# Access Compliance Report Public Rights-of-Way (Curb Ramps)

Main Street: JACKSON\_ST Cross Street: ELMORE\_WAY Location: SW

ADA ID: RPRK211005142345 Ramp Type: Type 1 - Perpendicular Diagonal Initial Pass/Fail: Fail Overall Compliance: No Severity Score: 16

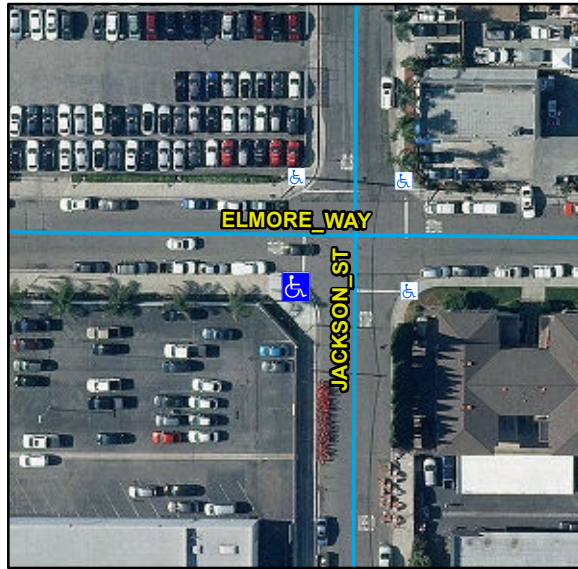
| Compliance | Description                           | Data | Compliance | Description                   | Data |
|------------|---------------------------------------|------|------------|-------------------------------|------|
| No         | Ramp Run Slope (%)                    | 8.5  | N/A        | Flare Slope LT (%)            | N/A  |
| No         | Ramp Cross Slope (%)                  | 3.1  | N/A        | Flare Traversable LT          | N/A  |

**Remove & Replace Curb Ramp With Two New Directional Ramps or Equivalent.**

**R304.2.2, R304.5.3, STD 1115**
